# HORSESHOE RIDGE SUBDIVISION 1ST AMENDMENT

## SITE PLAN REVIEW

THE LEARNING EXPERIENCE

SITE PLAN REVIEW

SHEET INFORMATION  
**C-1.0**

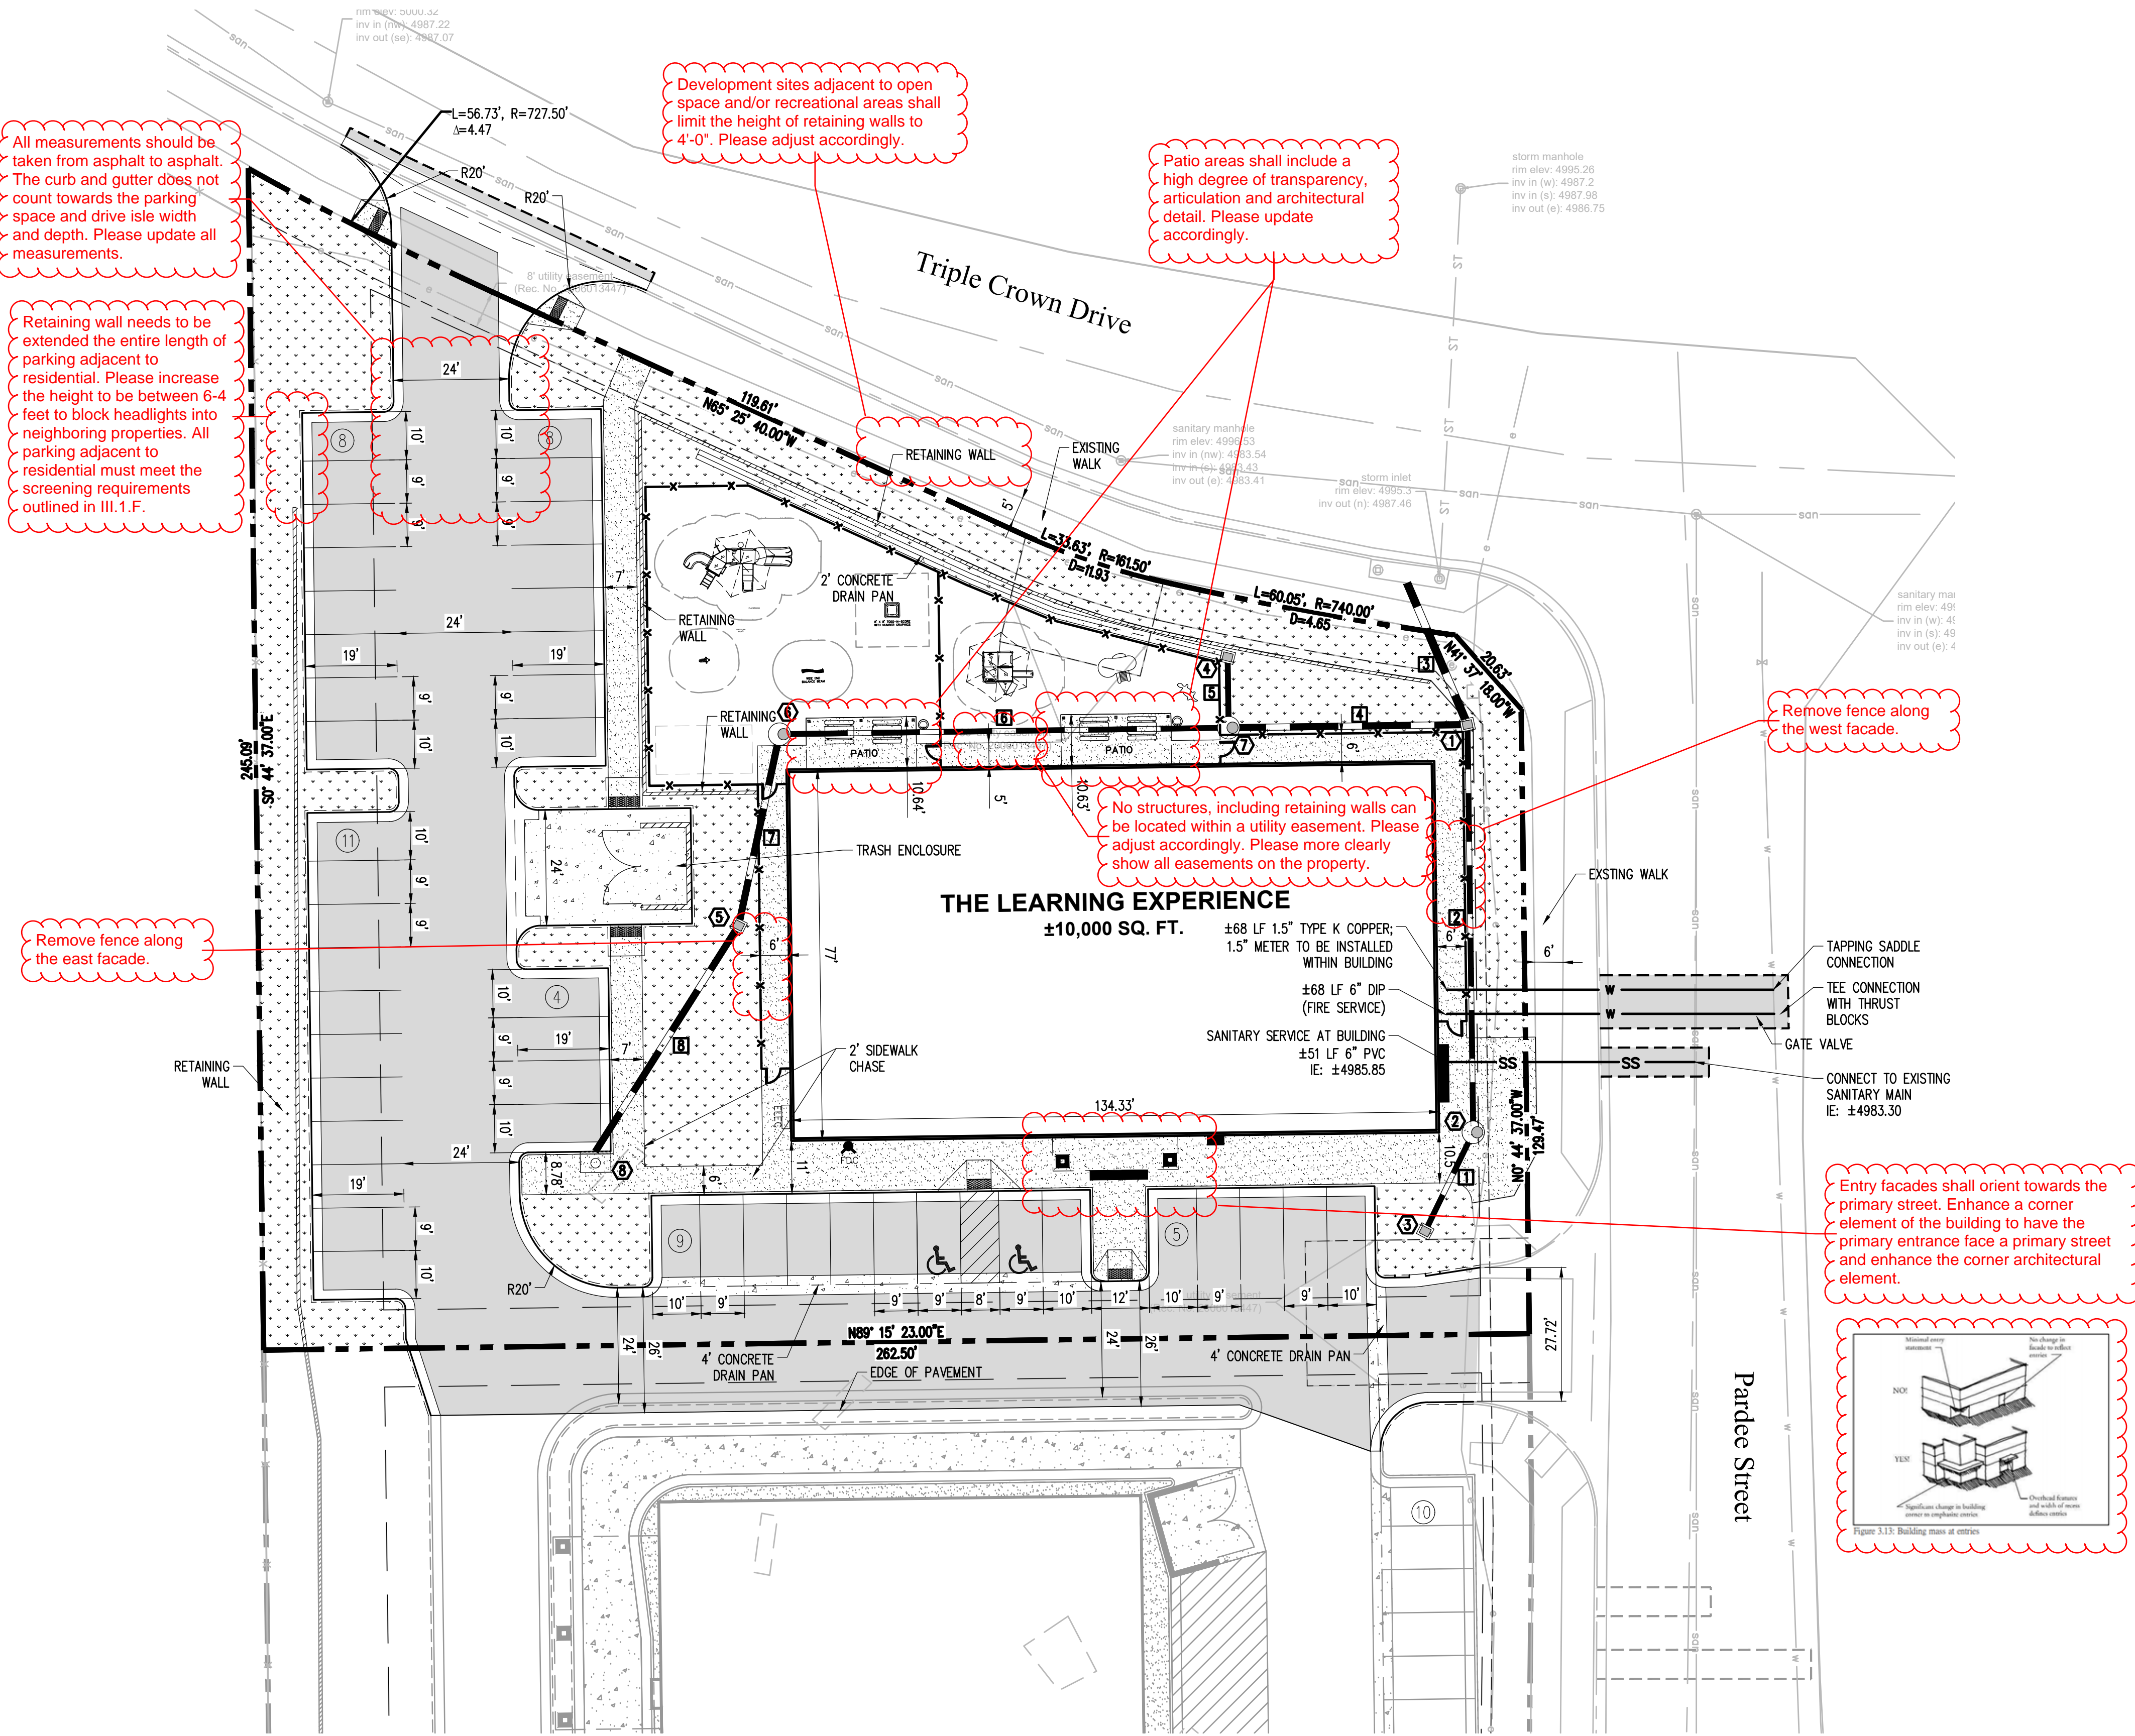
All measurements should be taken from asphalt to asphalt. The curb and gutter does not count towards the parking space and drive aisle width and depth. Please update all measurements.

Retaining wall needs to be extended the entire length of parking adjacent to residential. Please increase the height to be between 6-4 feet to block headlights into neighboring properties. All parking adjacent to residential must meet the screening requirements outlined in III.1.F.

Development sites adjacent to open space and/or recreational areas shall limit the height of retaining walls to 4'-0". Please adjust accordingly.

Patio areas shall include a high degree of transparency, articulation and architectural detail. Please update accordingly.

Please indicate on the site plan where the eight bicycle parking spaces will be provided. Please provide a bicycle parking detail in order to determine if the proposed structure meets the requirements outlined in Section 13.06.060.

Remove fence along the west facade.

Remove fence along the east facade.

No structures, including retaining walls can be located within a utility easement. Please adjust accordingly. Please more clearly show all easements on the property.

Entry facades shall orient towards the primary street. Enhance a corner element of the building to have the primary entrance face a primary street and enhance the corner architectural element.

Project Number: **2019.13** Scale: **AS NOTED**  
 Drawn By: **ROGUE** Approved By: **SAB**  
**PROPOSED EXTERIOR ELEVATIONS**  
 Drawing Number: **A-1**

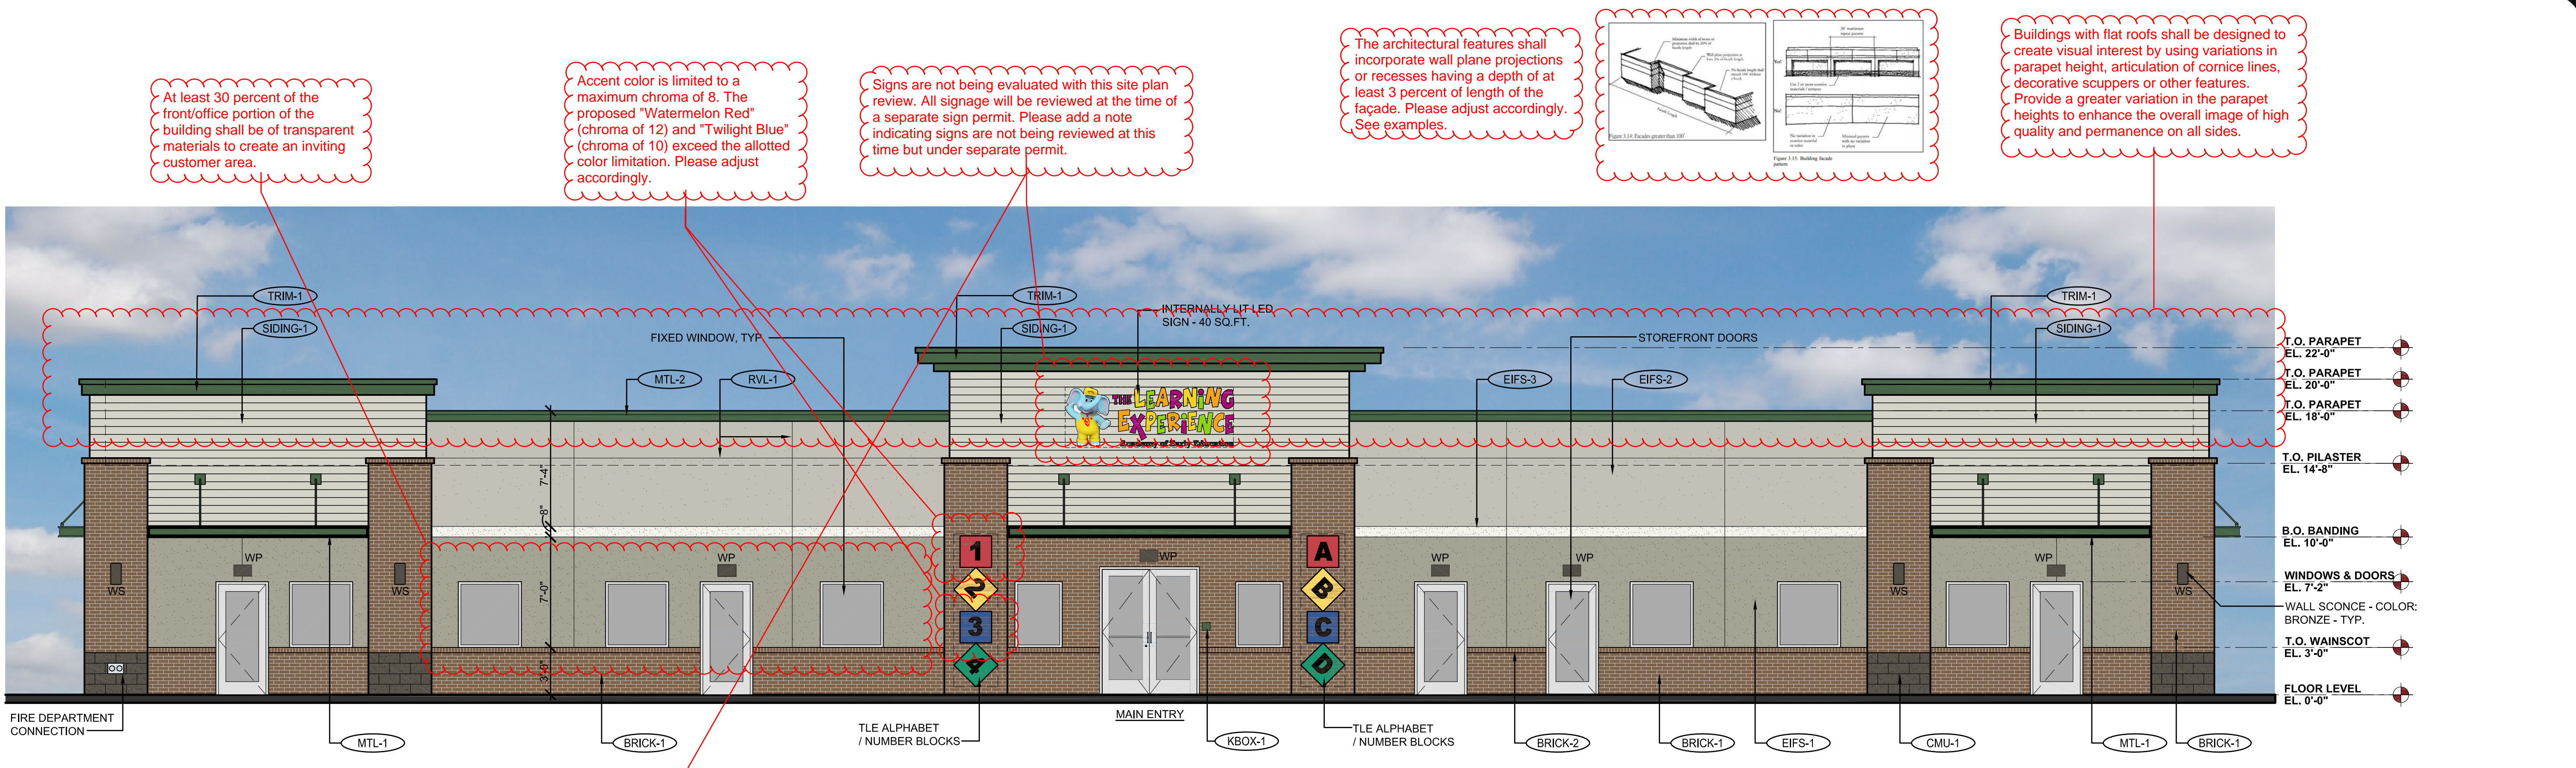
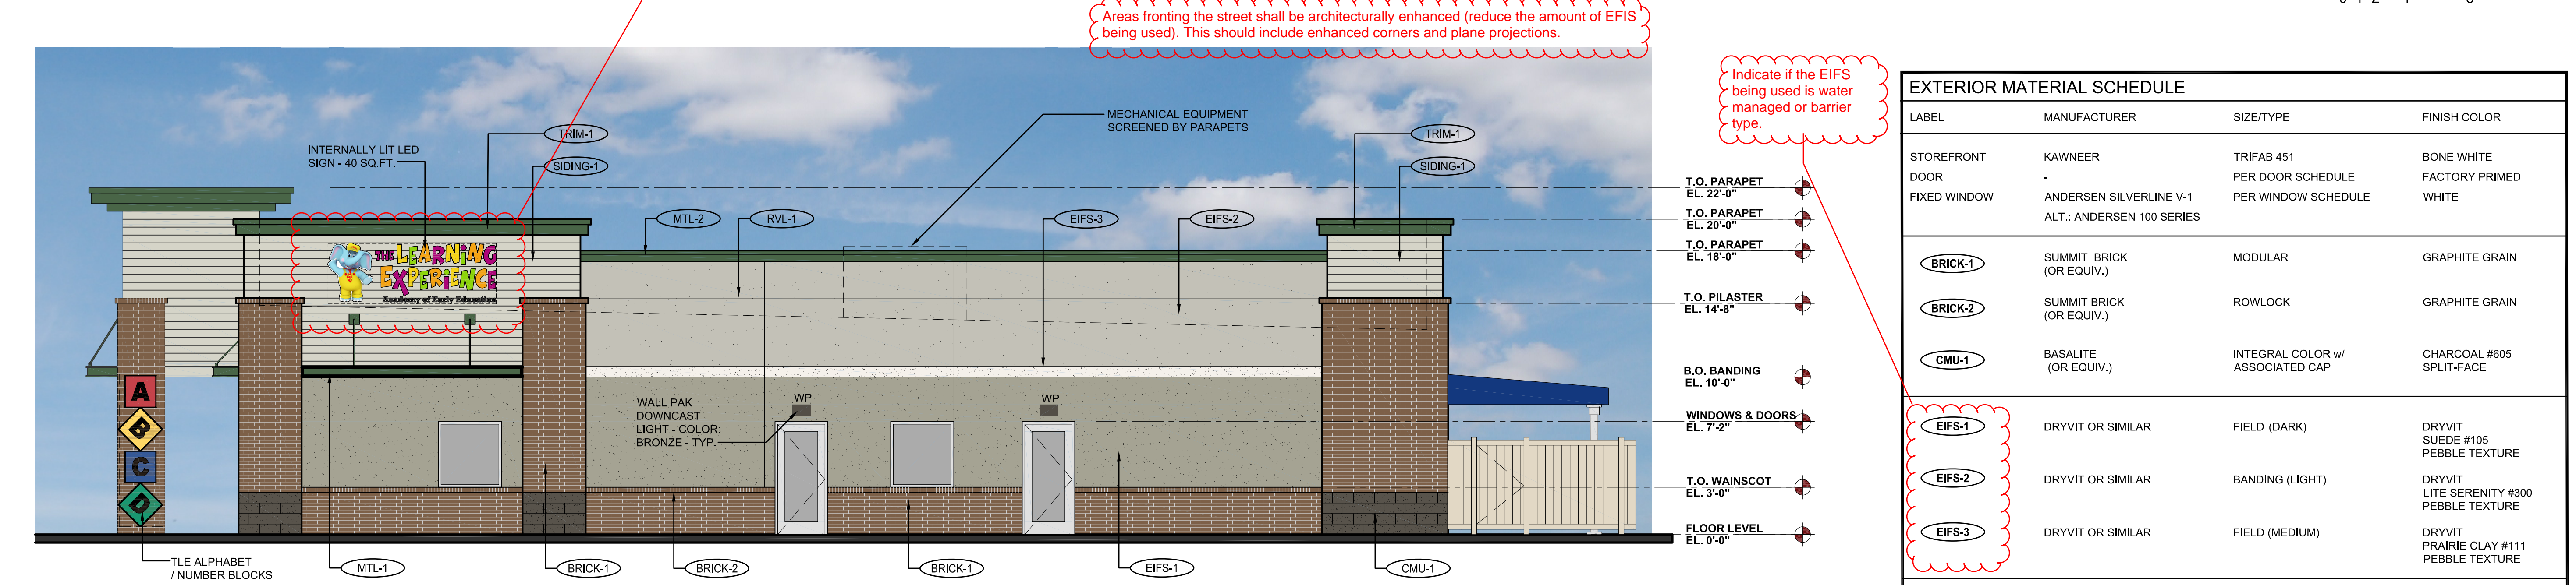
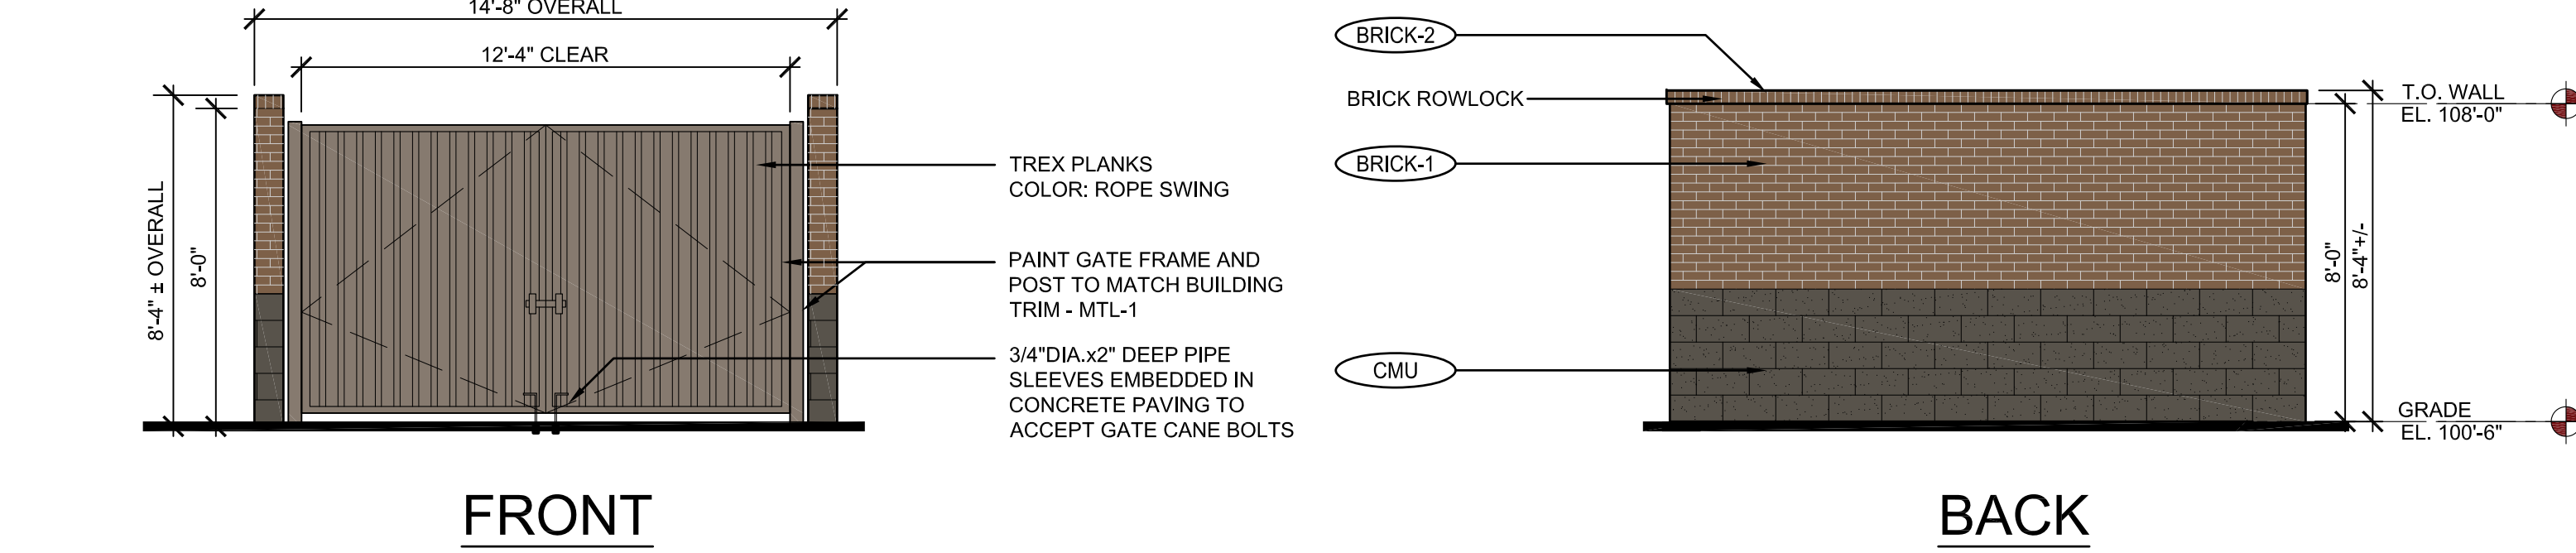
At least 30 percent of the front/office portion of the building shall be of transparent materials to create an inviting customer area.

Accent color is limited to a maximum chroma of 8. The proposed "Watermelon Red" (chroma of 12) and "Twilight Blue" (chroma of 10) exceed the allotted color limitation. Please adjust accordingly.

Signs are not being evaluated with this site plan review. All signage will be reviewed at the time of a separate sign permit. Please add a note indicating signs are not being reviewed at this time but under separate permit.

The architectural features shall incorporate wall plane projections or recesses having a depth of at least 3 percent of length of the façade. Please adjust accordingly. See examples.

Buildings with flat roofs shall be designed to create visual interest by using variations in parapet height, articulation of cornice lines, decorative scuppers or other features. Provide a greater variation in the parapet heights to enhance the overall image of high quality and permanence on all sides.

Areas fronting the street shall be architecturally enhanced (reduce the amount of EIFS being used). This should include enhanced corners and plane projections.

Indicate if the EIFS being used is water managed or barrier type.
